CAP Aviation 9, rue de l'Aviation 21121 DAROIS - France Tel +33 380 35 65 10 Fax +33 380 35 65 15 www.capaviation.com	<b>S E R V I C E   B U L L E T I N</b>	
<b>NUMBER</b>	<b>TITLE</b>	<b>ATA SYSTEM</b>
010301	Canopy handle	56

Inform users about canopy handle replacement and new parts references.

Present Southco handle (reference: 92-42-531) replacing CAP10-10-19-06B.

### 2.2.2 Removal of canopy handle assembly

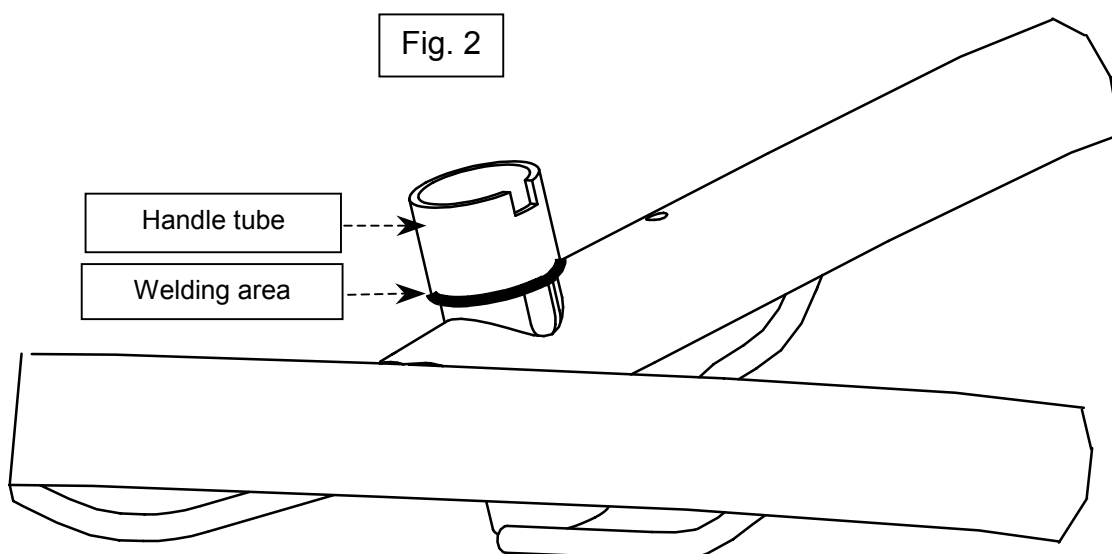
- Remove hexagonal socket head screw from lower handle.
- Remove canopy handle assembly.

- Install handle inserting new parts (refer to figure 1).
